**STORMWATER DRAINAGE IMPROVEMENTS PROJECT
FOR FRANCIS MARION UNIVERSITY (H18-N079-MJ) (EDA#04-01-07484.01)**

Subject: Addendum #3

Date: November 30th, 2022

DRAWING NUMBER:
C-201

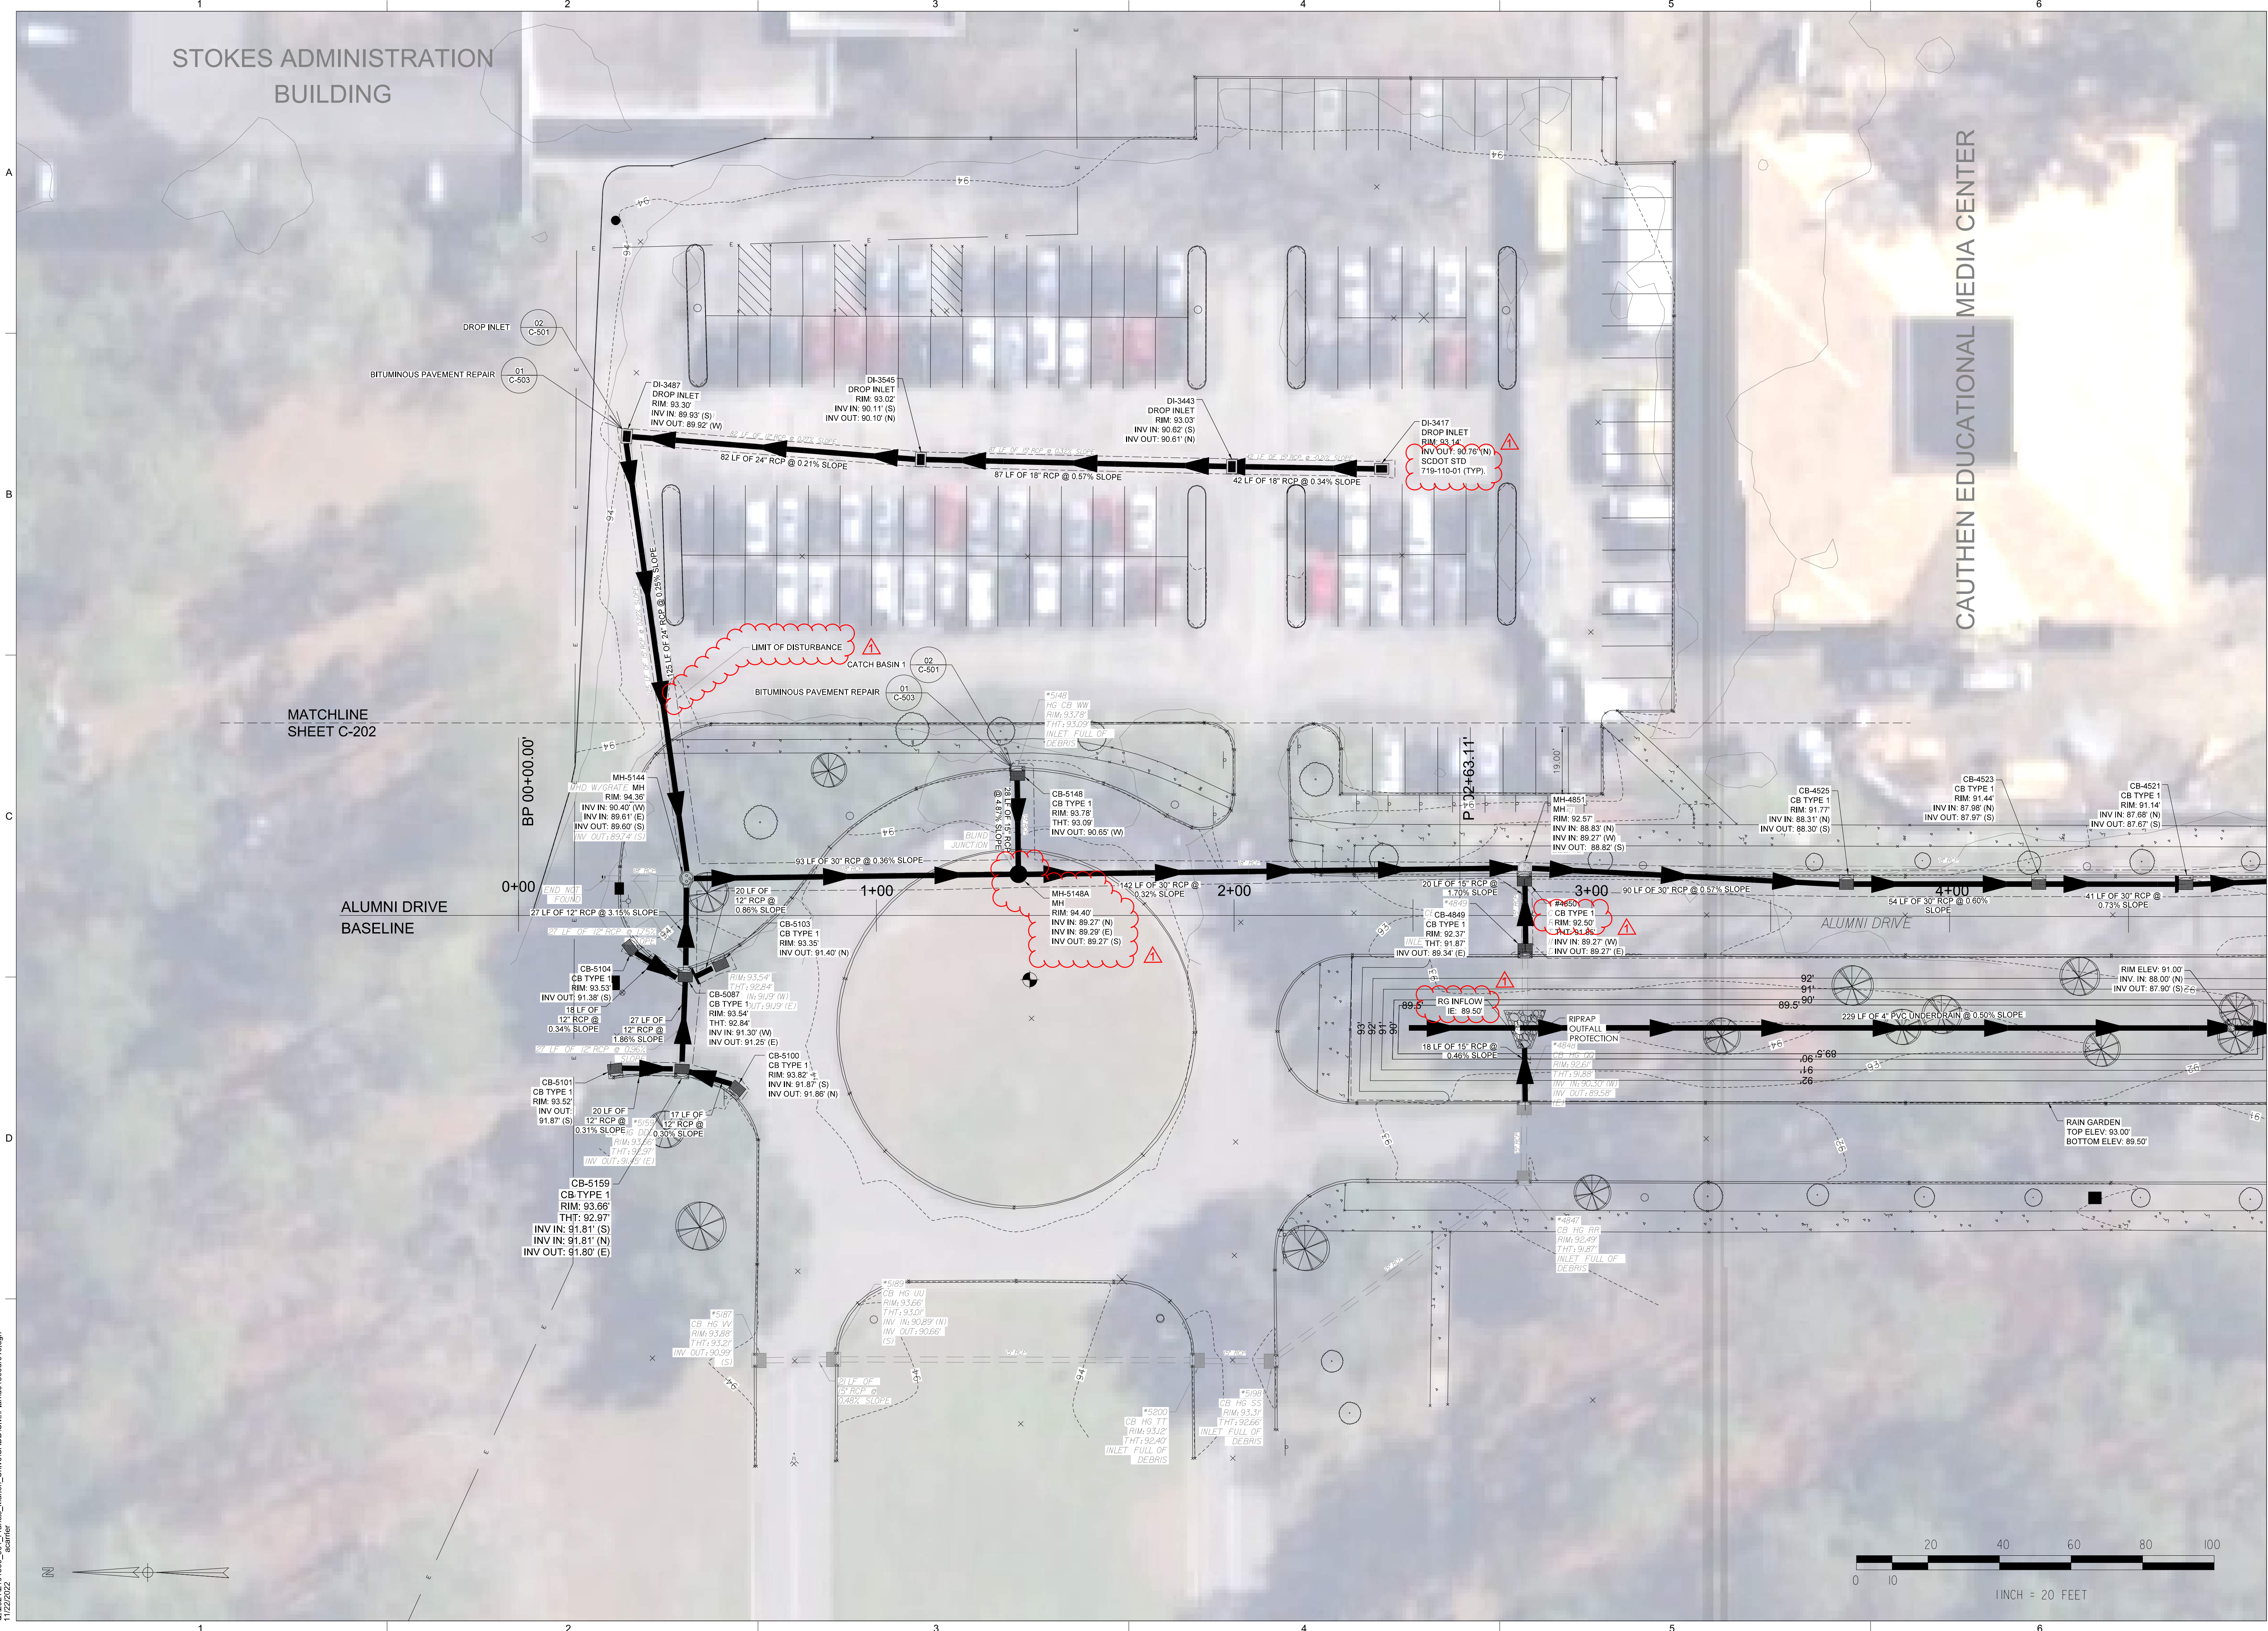
1. Sheet C-201 – Added Drop Inlet typical note, added limit of disturbance leader, replaced blind junction with MH-5148A, revised RG Inlet to RG Inflow, revised CB 4850 inlet type.

3. On Sheet C-201 & C-202, there is an existing blind junction, and a new manhole (MH-5148A) has been added to this location.
4. Sheet C-207: There is no difference in structure type of Structures DI-3233 and DI-3234.

C-203

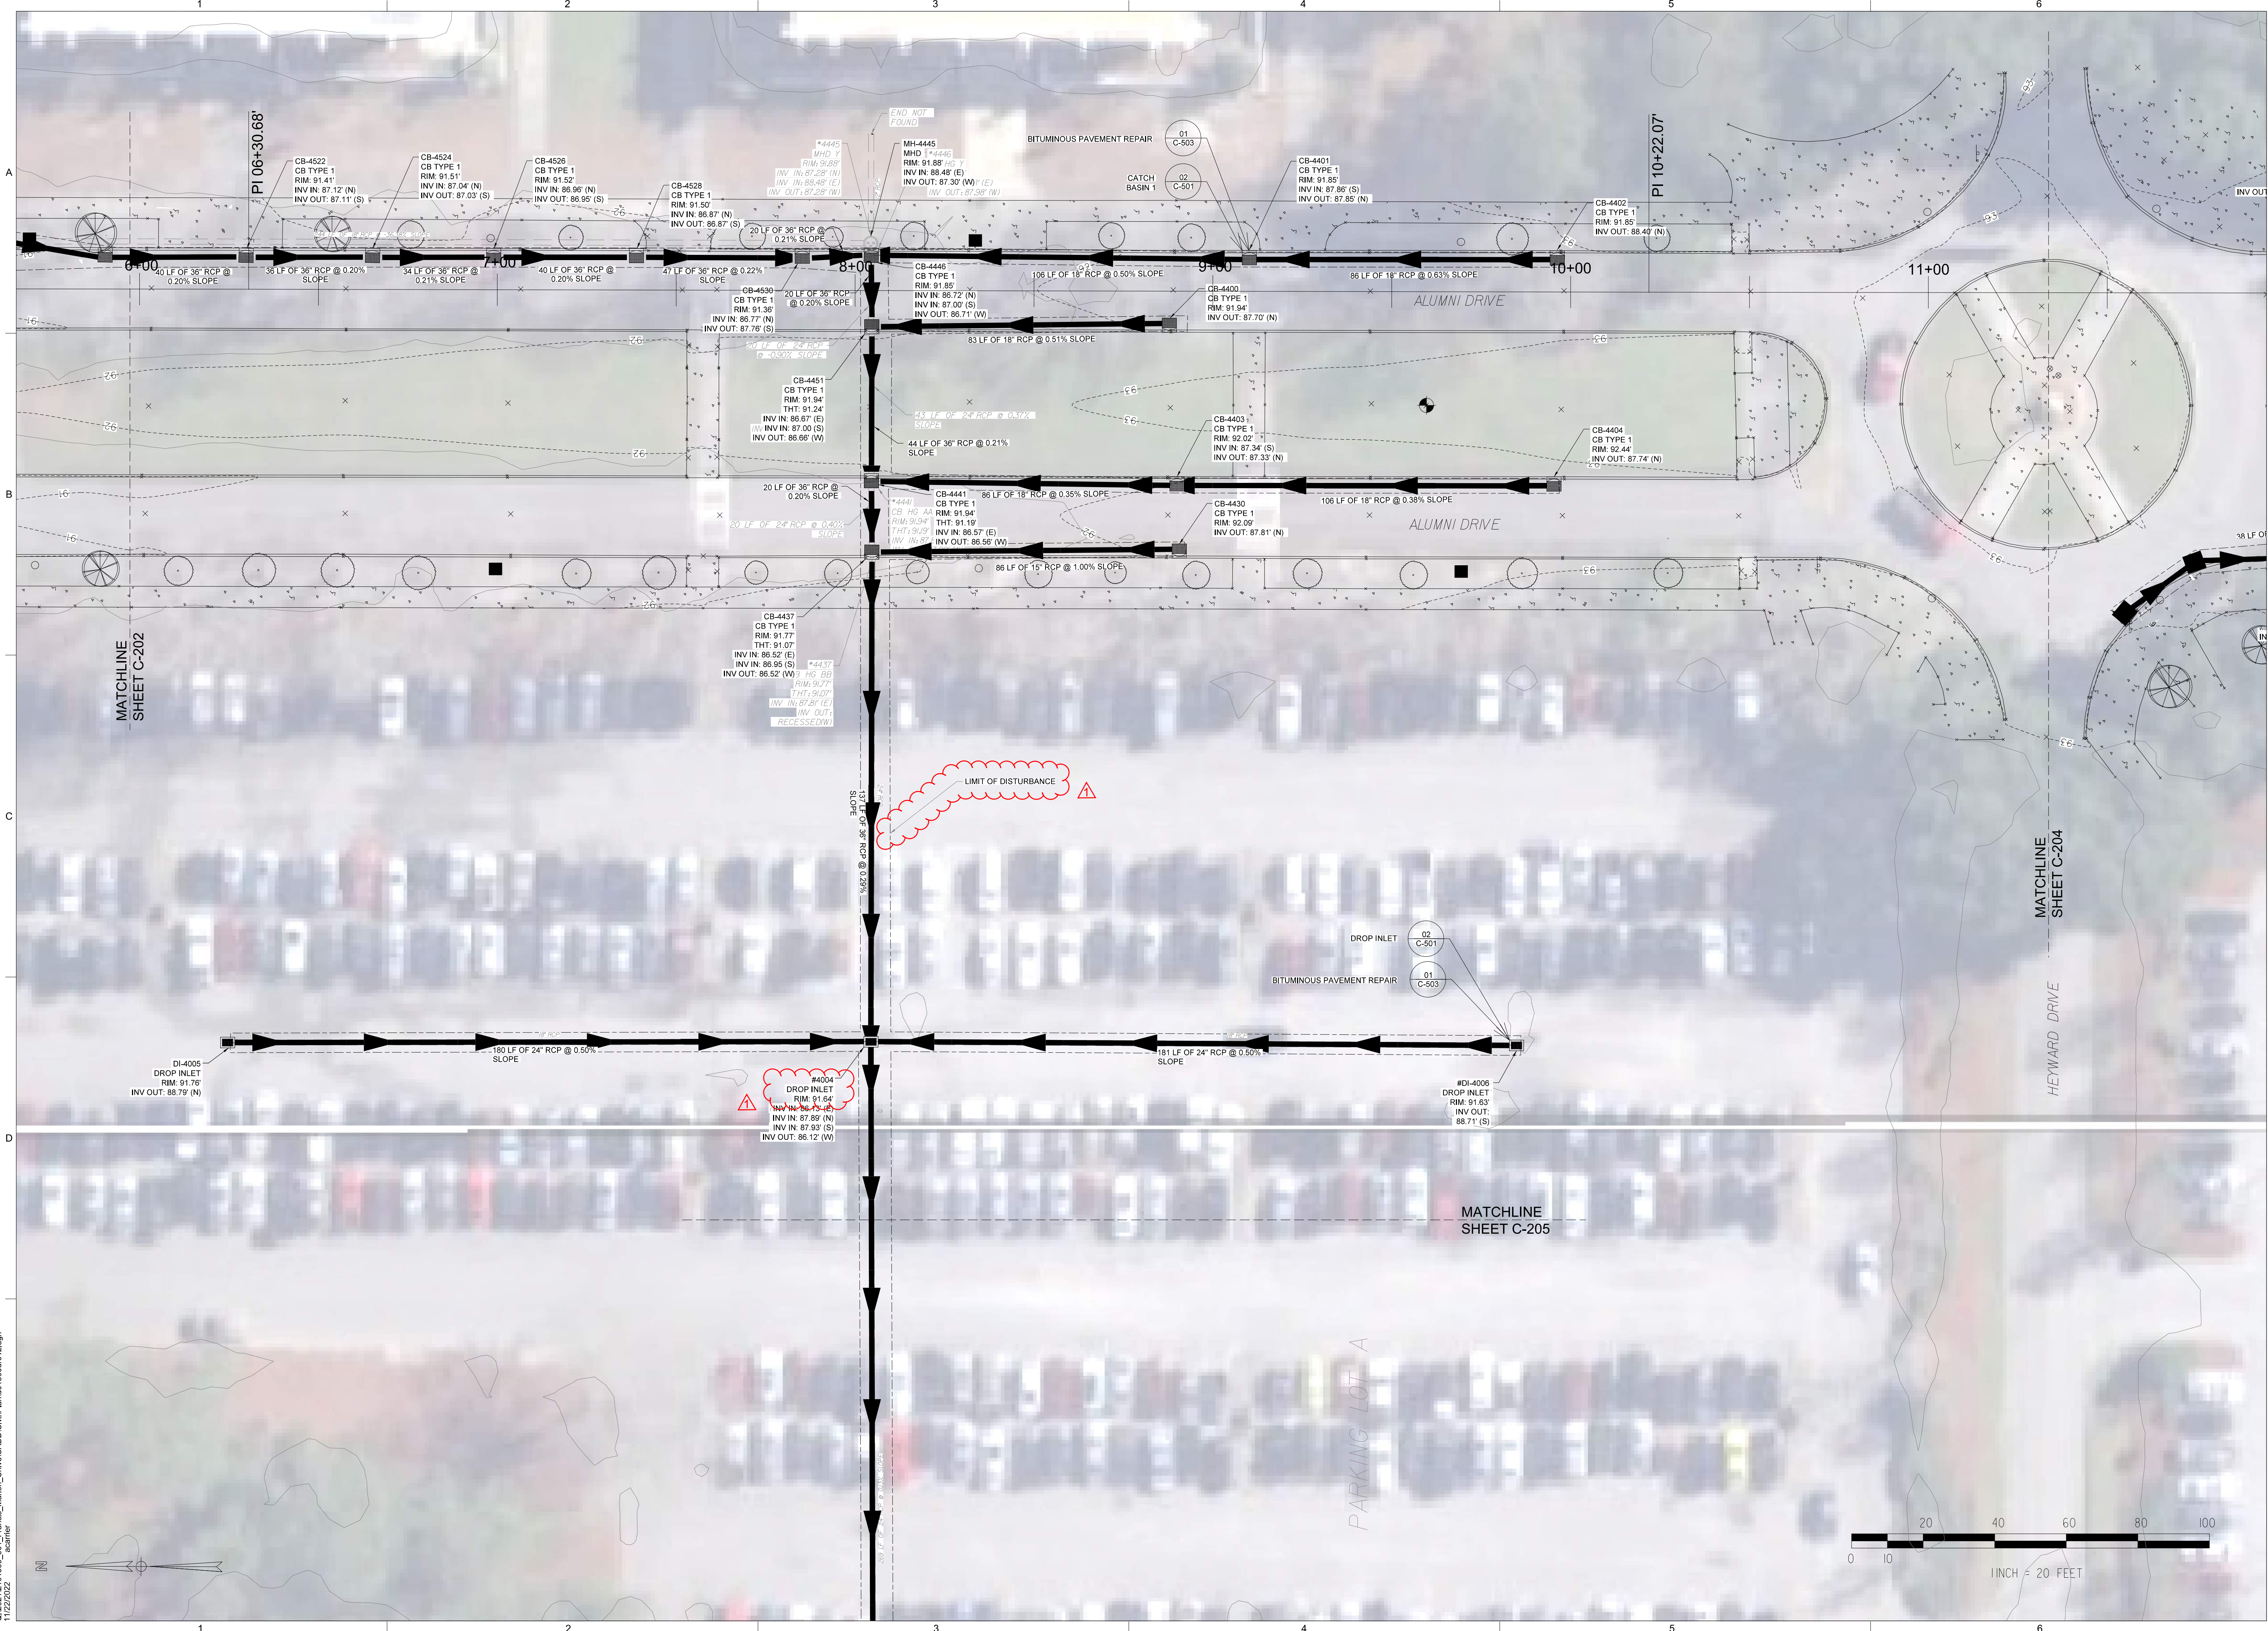
2. Sheet C-202 – Added limit of disturbance leader, replaced blind junction with MH-5148A, revised RG Inlet to RG Inflow, revised CB 4850 inlet type.
3. Sheet C-203 – Added limit of disturbance leader, revised CB 4004 inlet type.

STANDARD DRAWING
DROP INLET (24"X36") DETAILS

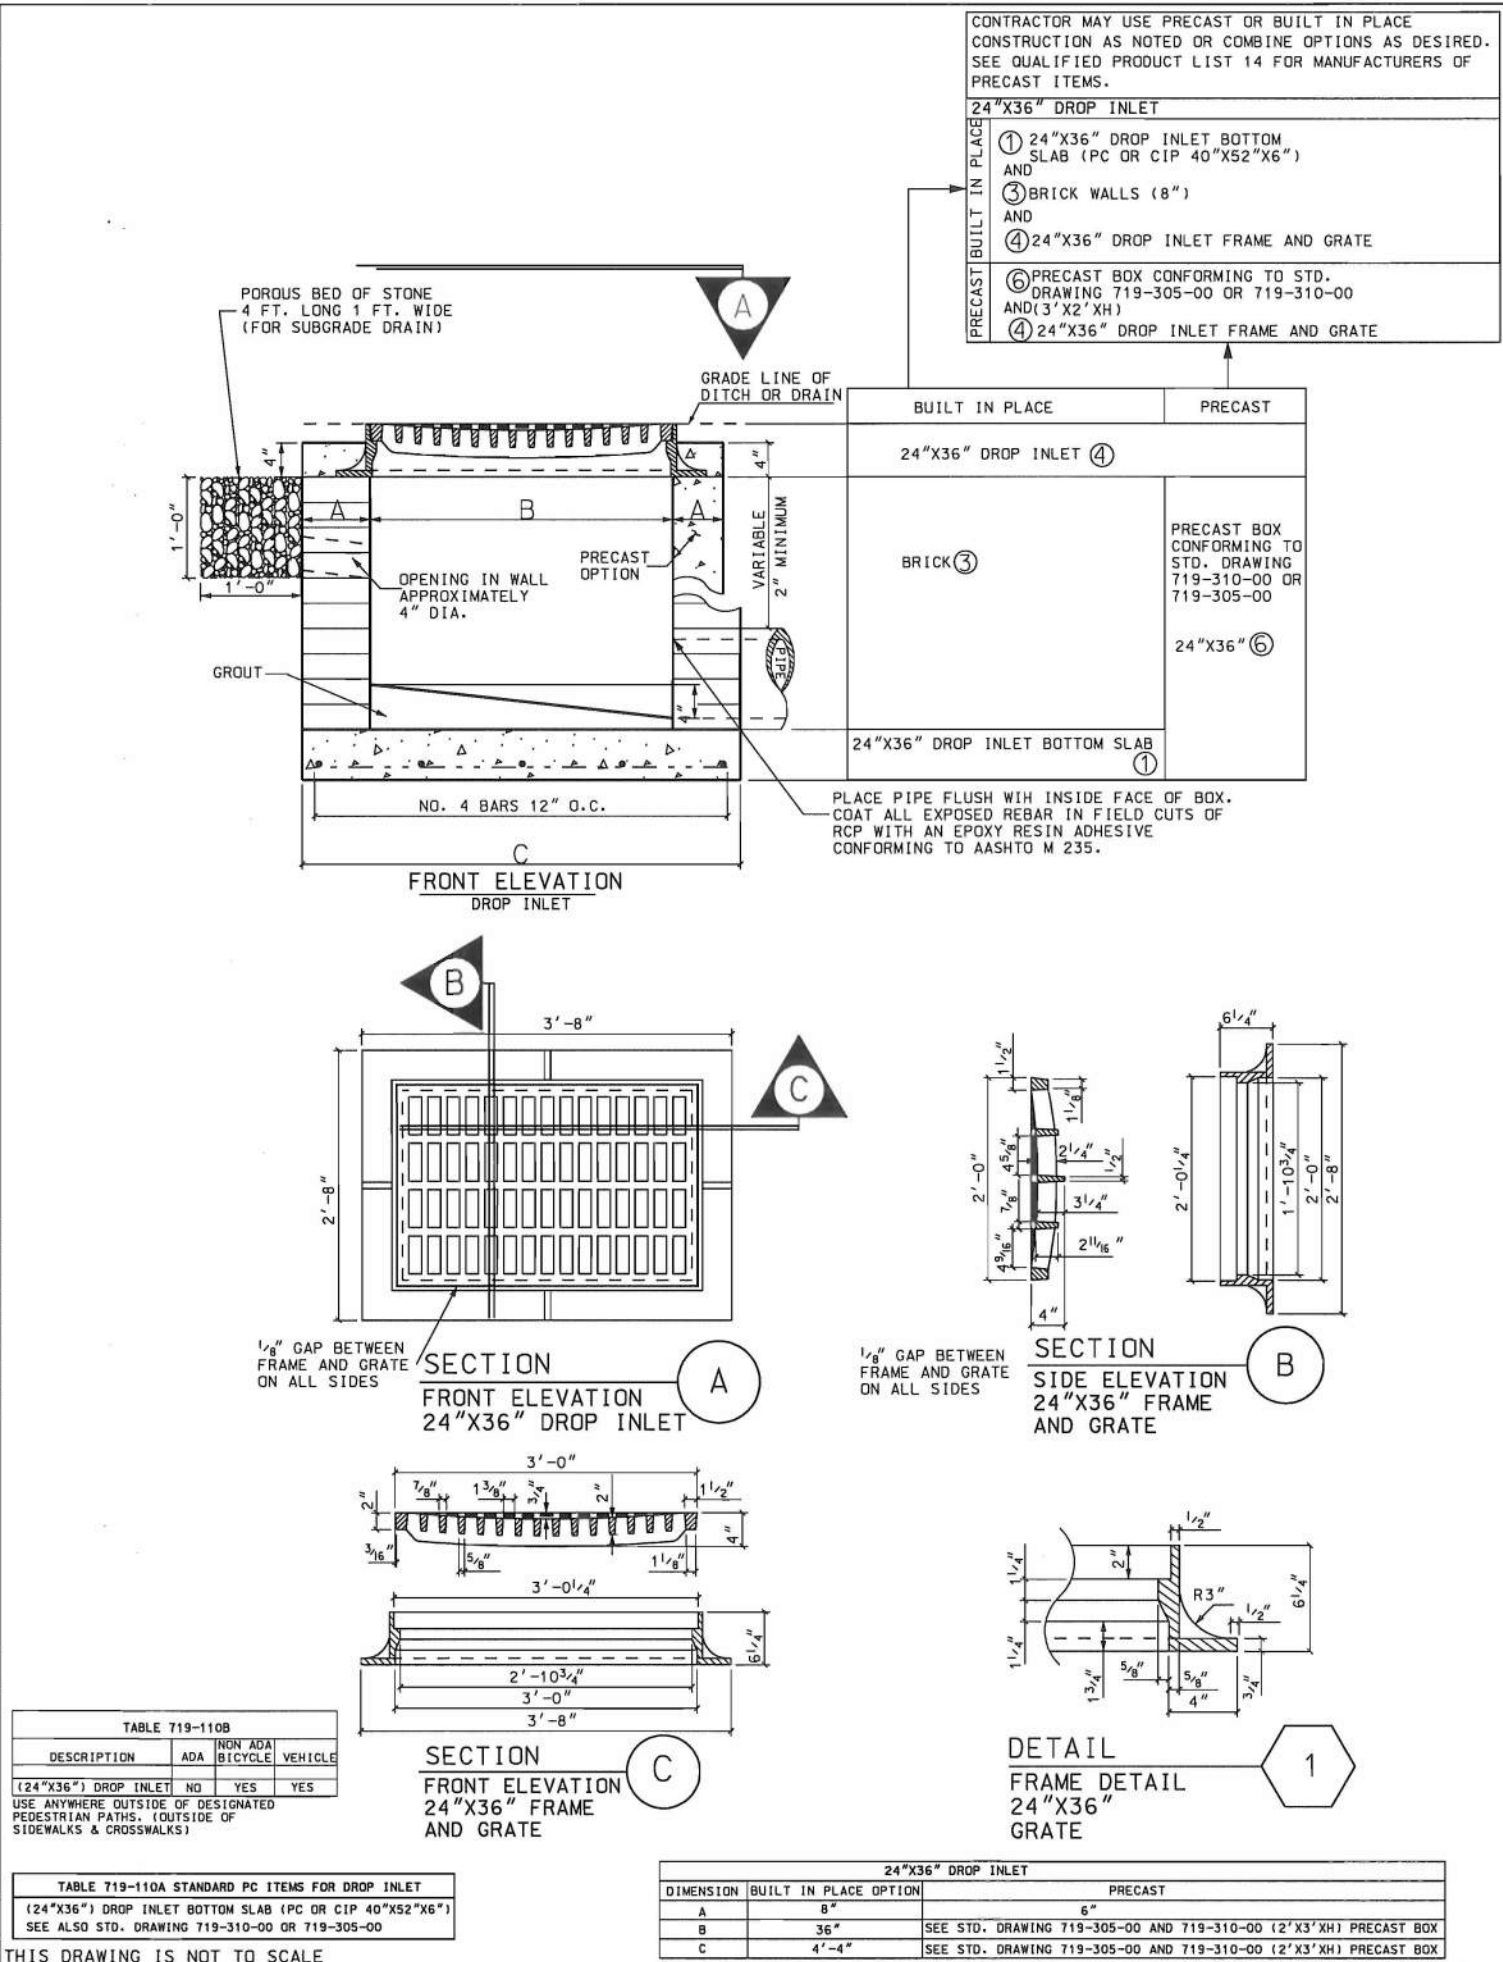
1. Additional details for drainage structures have been provided on the plans. CB Type 1 is the SCDOT Standard Type 1 inlet. Callout has been revised to “CB Type 1” for all CB HG inlets. The conveyance system is to be constructed in accordance with standard SCDOT specifications. Refer to Drop Inlet on SCDOT standard drawing 719-110-01 for additional information. This standard detail has been included as part of this addendum for clarity.
